Ashton Village Center

SECTOR PLAN

Ashton Village Center Sector Plan

Work Session #2

Southeast Quadrant

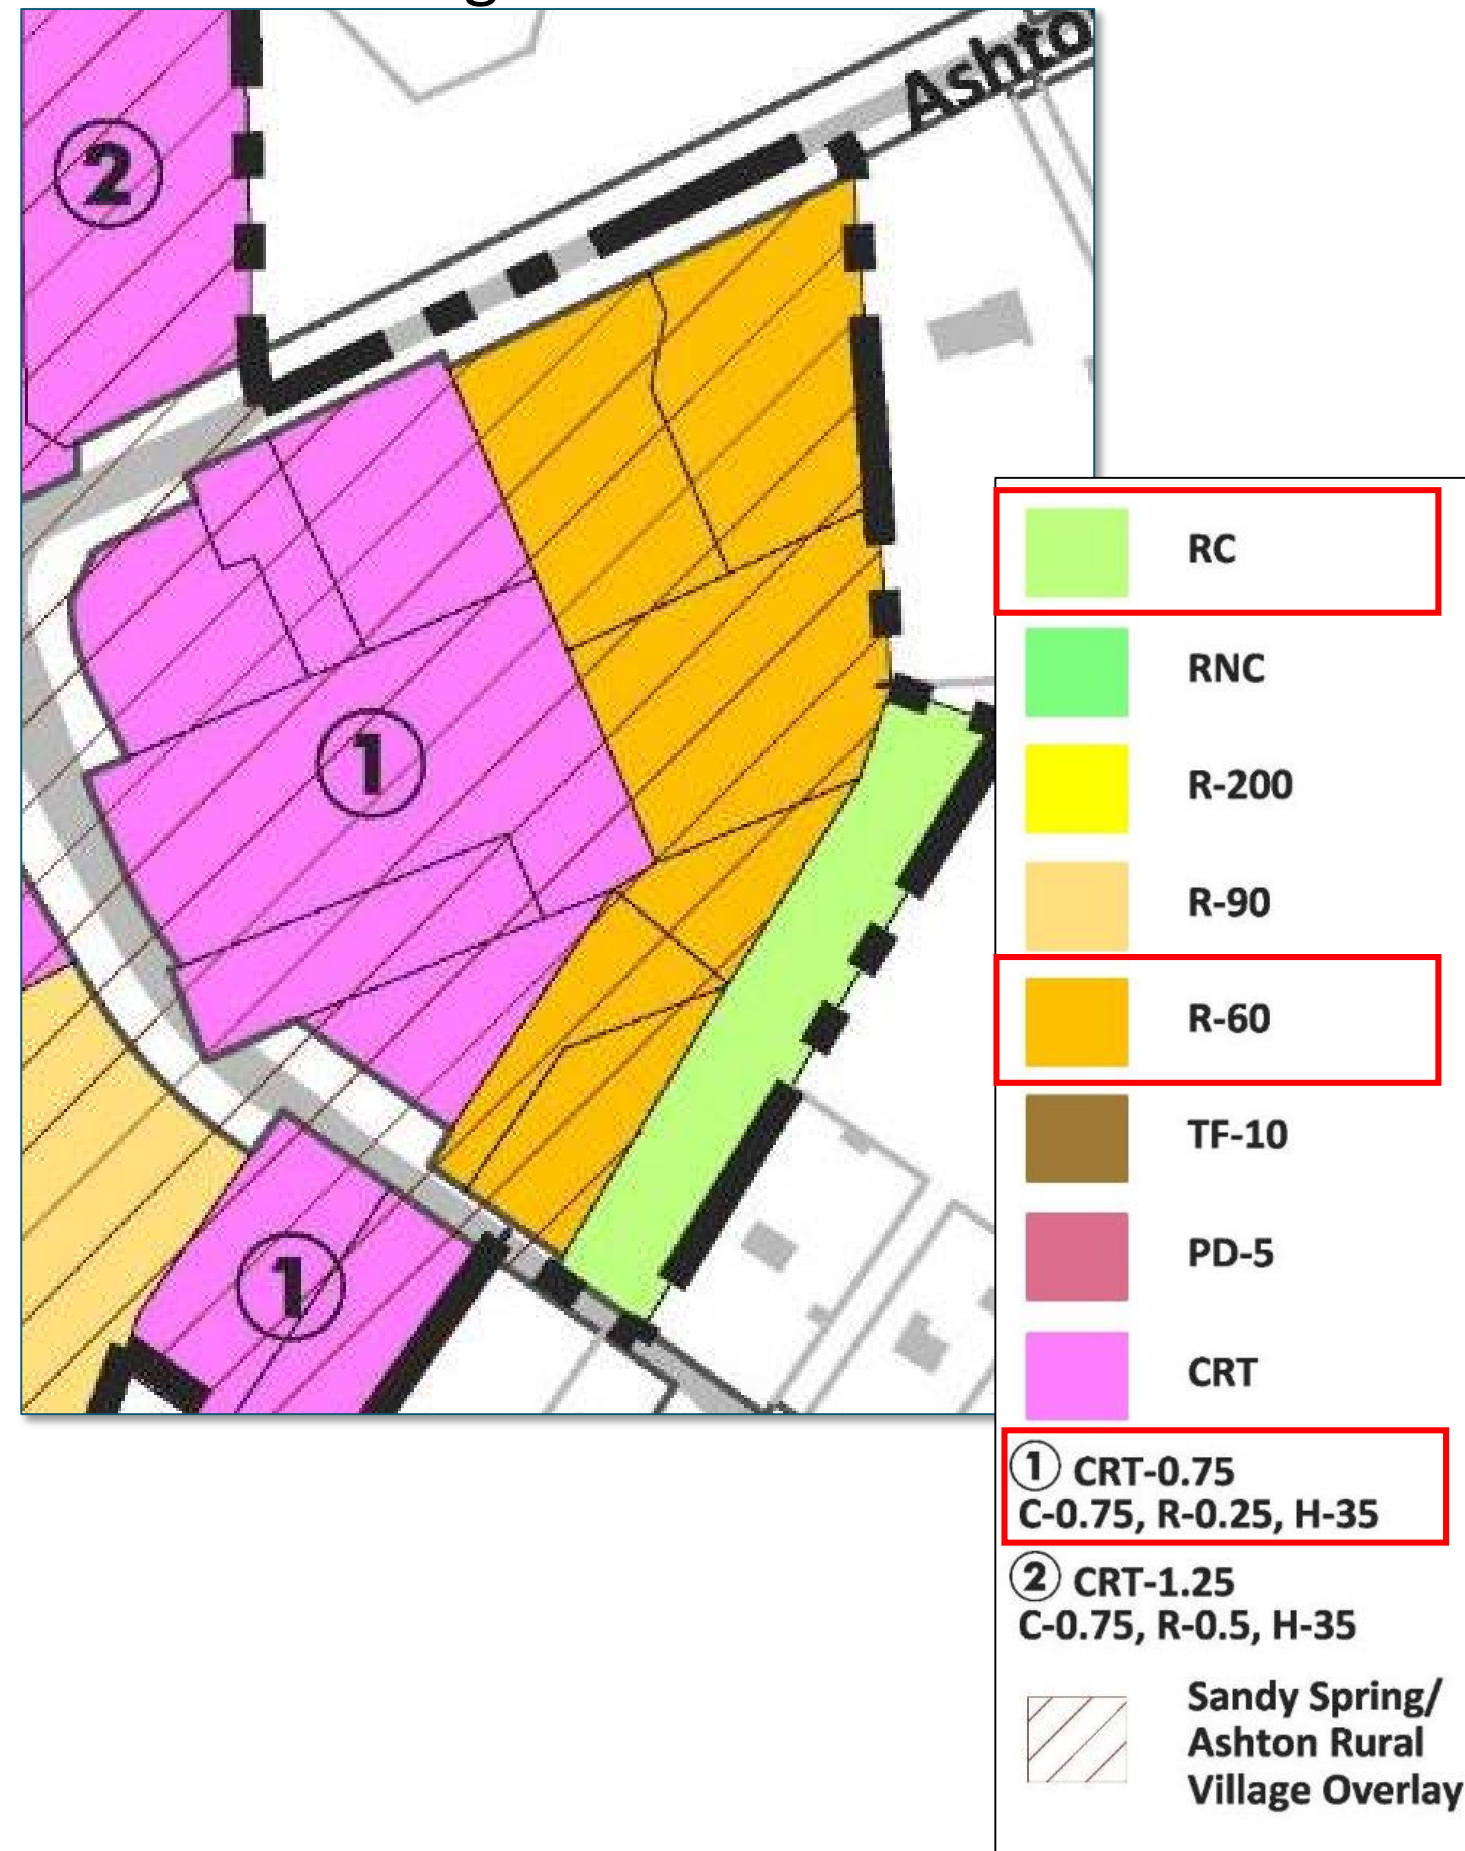
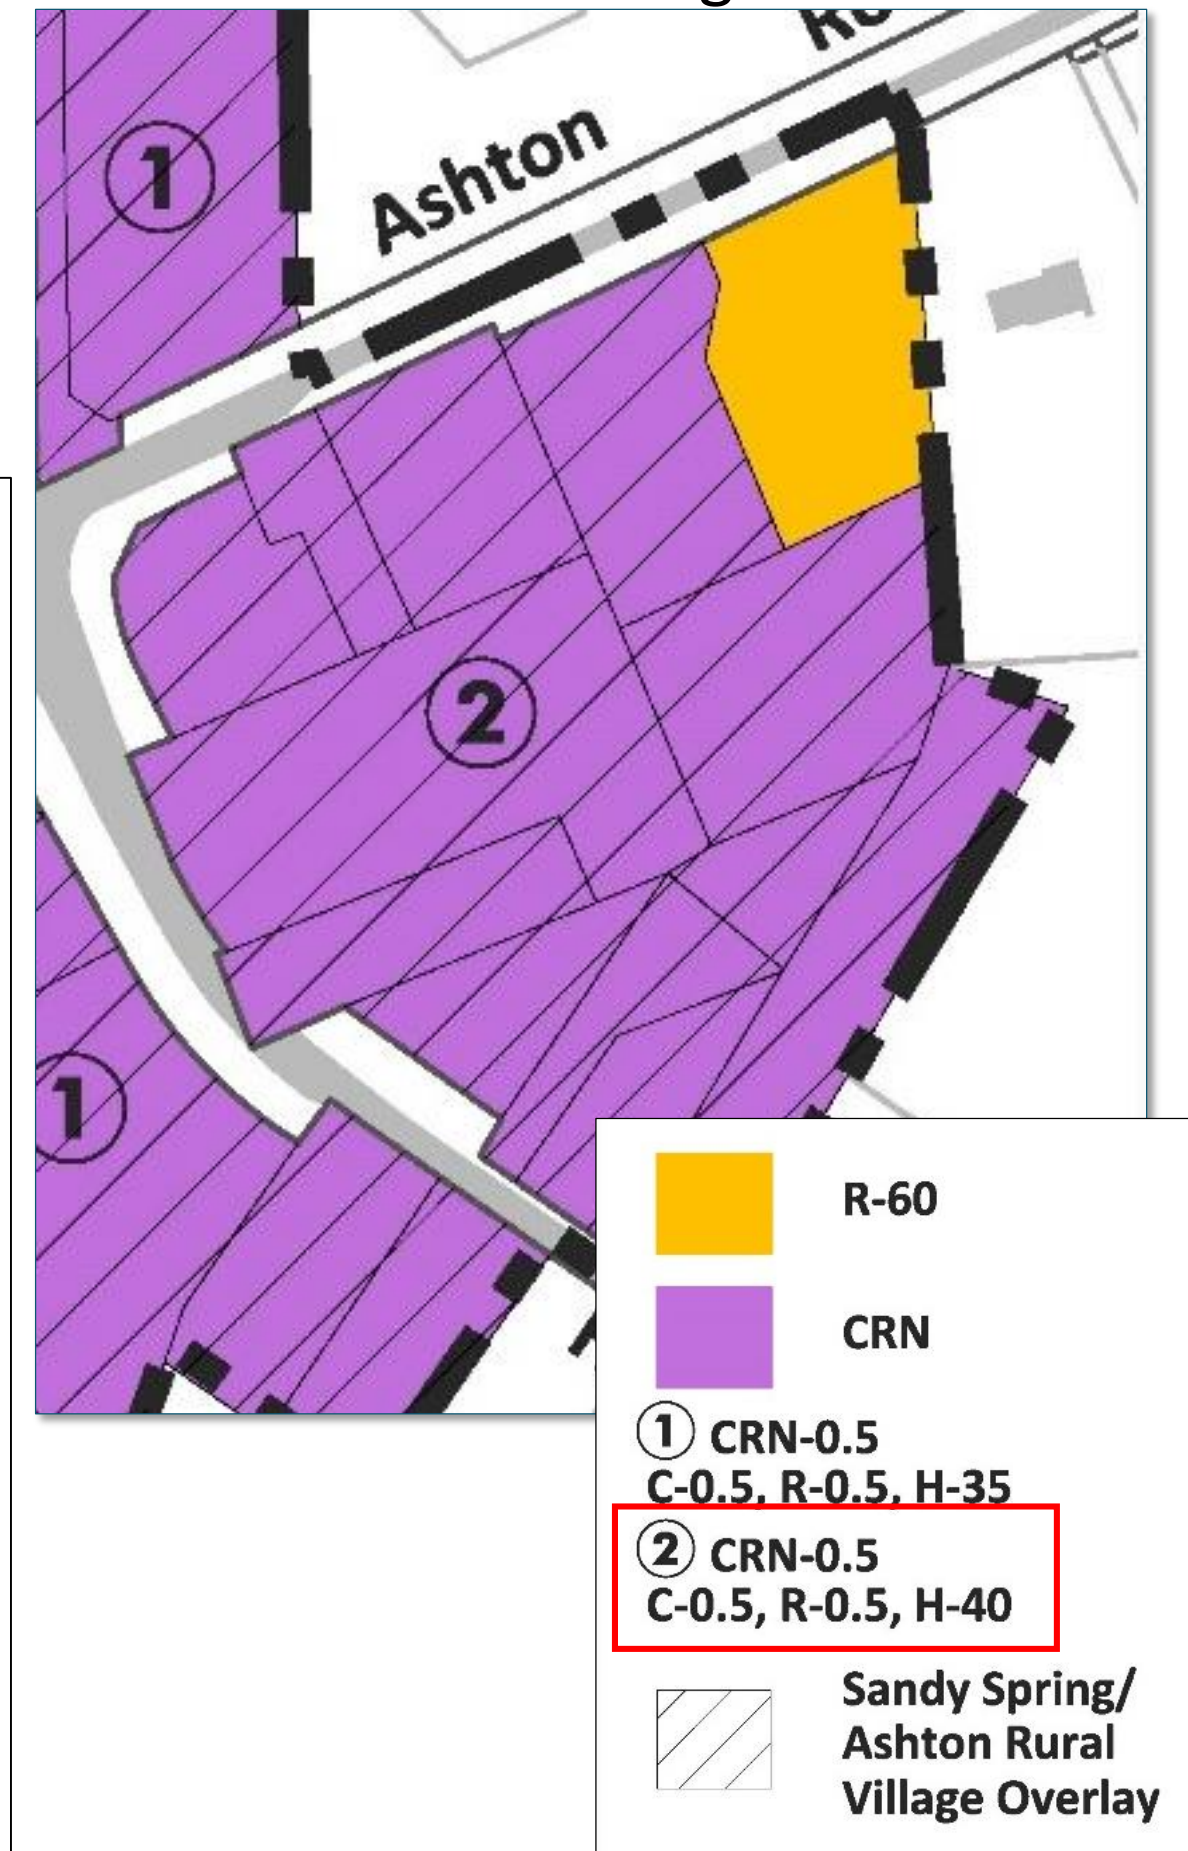
- Much feedback: too dense and too high
- Property owner: Increase density and height:
CRN-0.75 C-0.5 R-0.5 H-45

- Housing needed in this area
- Property owner's request is marginal
- 0.75 FAR needed to achieve 0.55 or 0.6 FAR because assigned in .25 increments

- Retain the Plan’s recommendation
